**PETITION FOR CHANGE OF THE PROJECT DESCRIPTION IN THE FINAL  
DECISION TO ERECT AND UTILIZE A FABRICATION/REPAIR SHOP AND  
WATER LABORATORY BUILDING  
PALOMAR ENERGY CENTER  
(O1-AFC-24C)**

<b>DOCKET</b>	
<b>01-AFC-24C</b>	
DATE	<u>AUG 31 2010</u>
RECD.	<u>SEP 14 2010</u>

**SAN DIEGO GAS & ELECTRIC COMPANY  
SAN DIEGO, CALIFORNIA**

**CALIFORNIA ENERGY COMMISSION**

**SHEET TITLE:**  
ARCHITECTURAL SITE PLAN

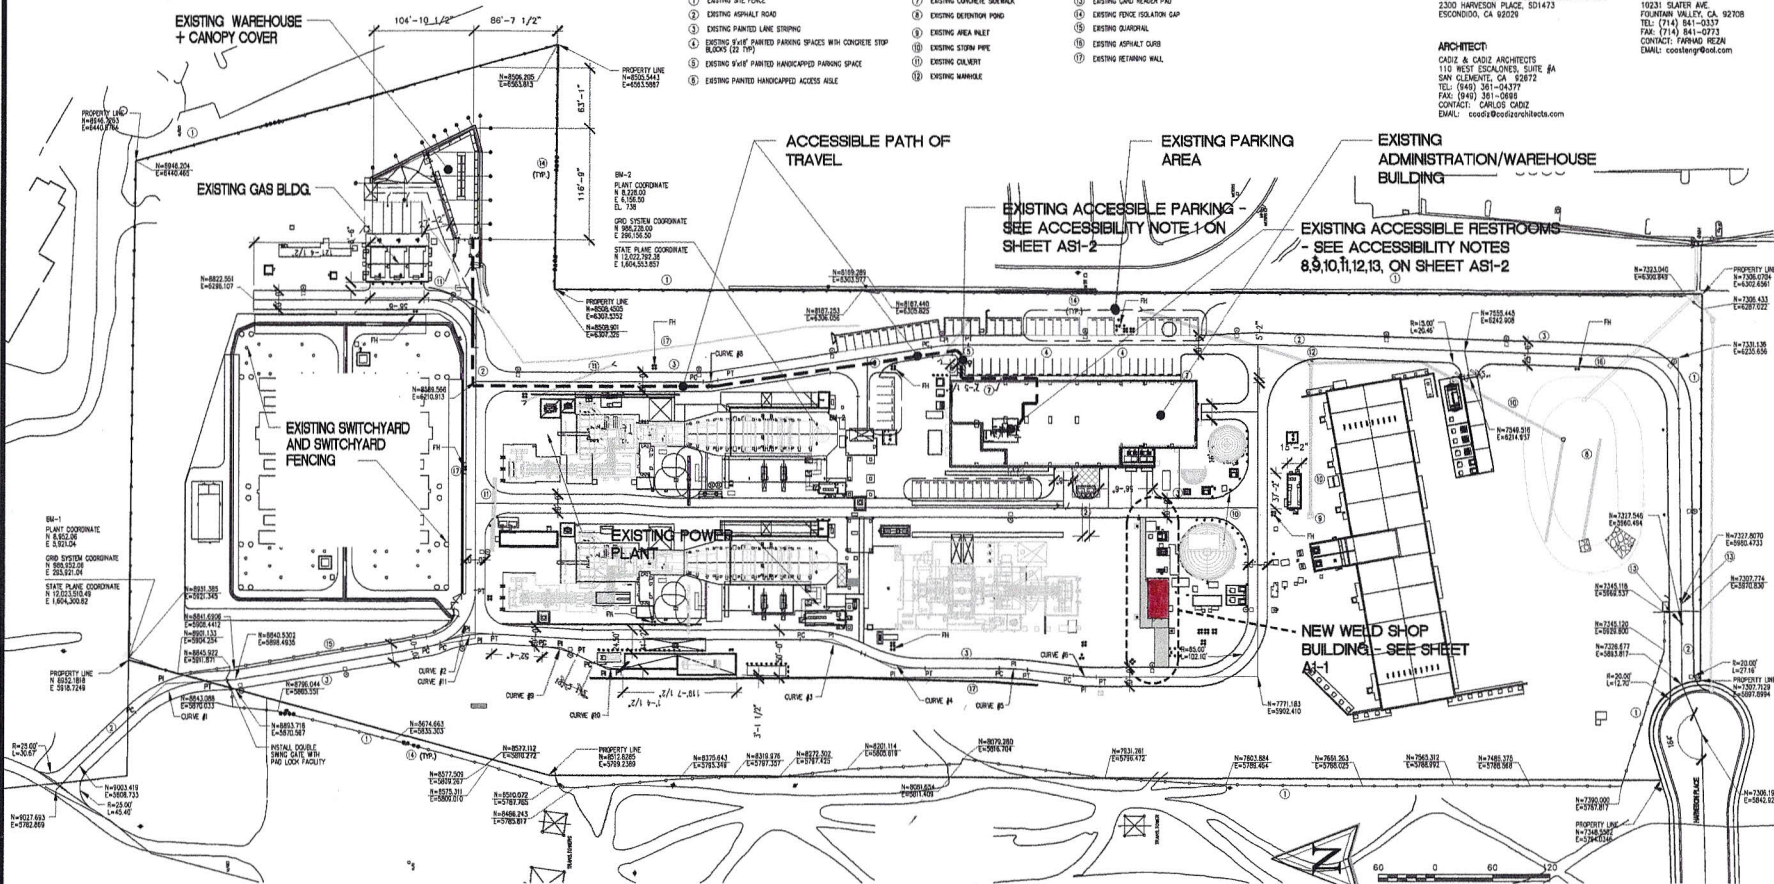
Fabrication/Repair Building. Fabrication and repair of parts and equipment is currently carried out within a section of the main administration building. PEC management need additional space to carry out these activities. Much of the maintenance activities the plant engages in requires clean work area due to the delicate nature of the equipment being repaired. Fabrication activities such as welding, grinding, and other similar work is incompatible with much of the other maintenance activities that take place in the current shop area. The new building will measure approximately 10x40x16 feet. It will be a metal sided double walled building of similar construction to the administration building.

The building will be located in the middle area of the plant site where previous excavation, backfill and compaction took place during plant construction. It will not be visible from off-site. The building will be painted the plant color (SW 1022 Cubist grey). Plot plans showing the location of the building and visual simulations are attached in Appendix 1.

**MASTER SITE PLAN**

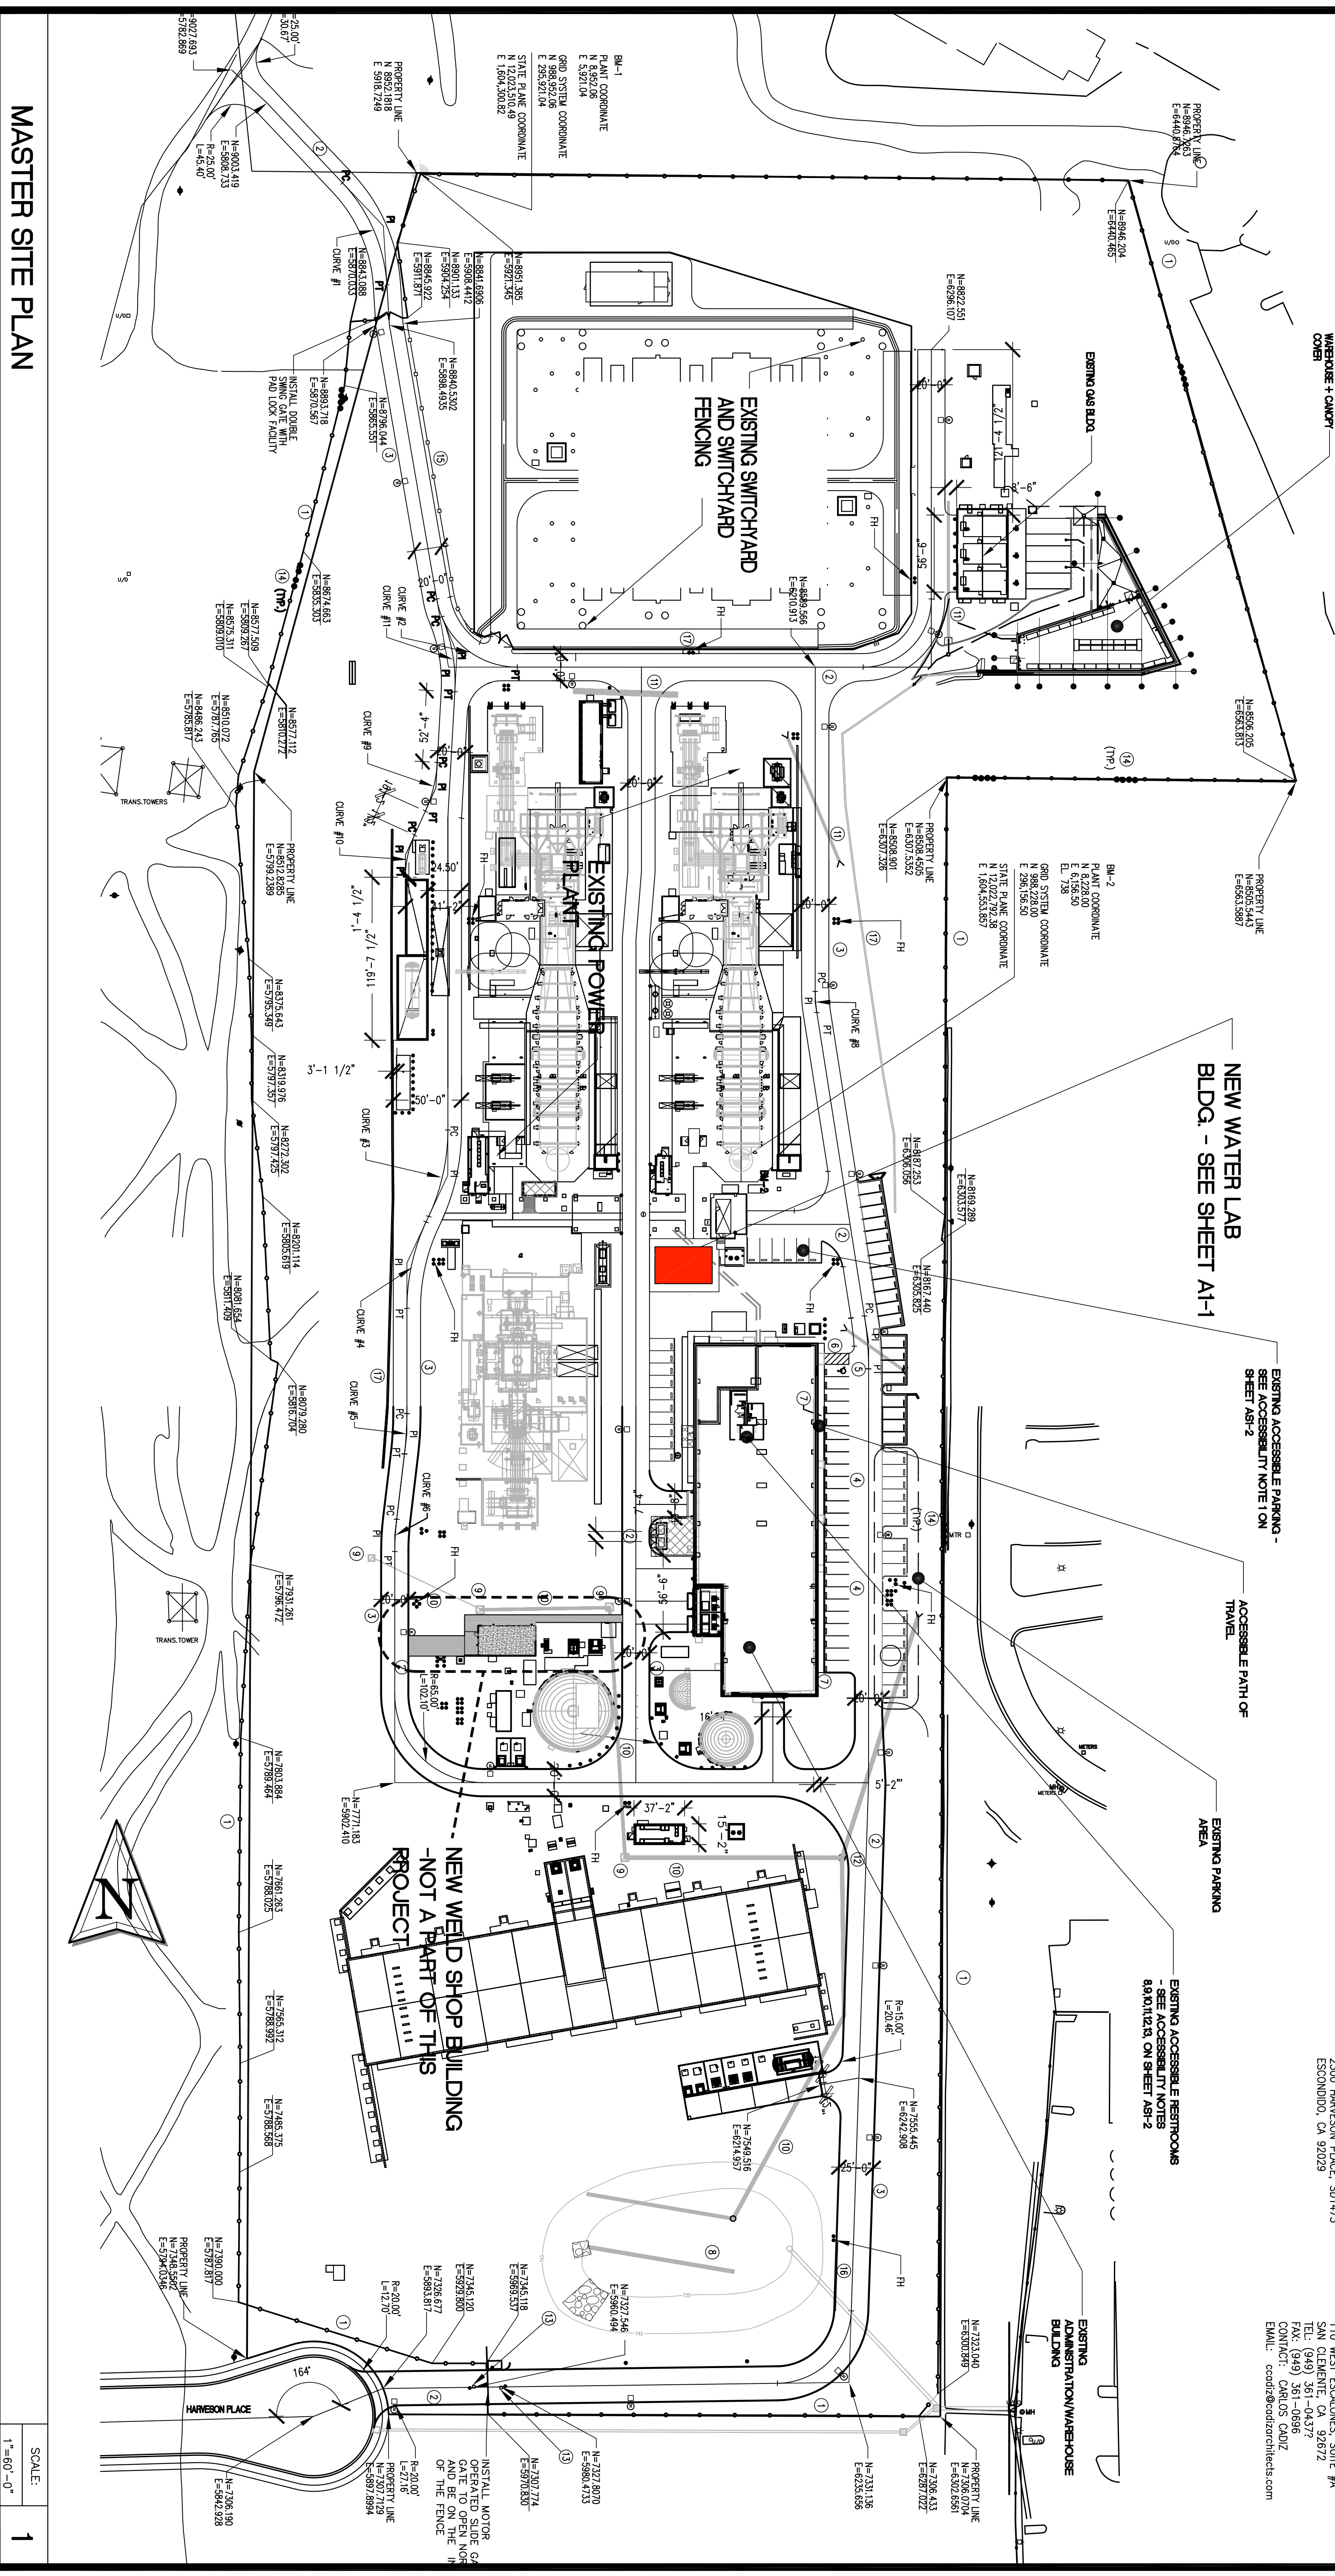
Laboratory and Restroom Building. Currently the plant's water laboratory is located within the administration building. The plant chemist must make several trips per shift to obtain samples from sample lockers elsewhere on the site. Construction of a small separate laboratory building will eliminate the need for these trips and consolidate more of the sample storage and water analysis functions at one location. The building would measure approximately 30 x 45 x 16 feet. The building would be located just north of the administration and south of the Unit 2 Heat Recovery Steam Generator. The building will be painted the plant color (SW 1022 Cubist grey). It would not be visible from off-site. Plot plans showing the location of the building and visual simulations are attached in Appendix 2.

Outside contractors currently must either be allowed access to the administration in order to use rest room facilities or use portable restrooms on site. PEC management proposes to add a restroom facility to the same building that will house the water laboratory.
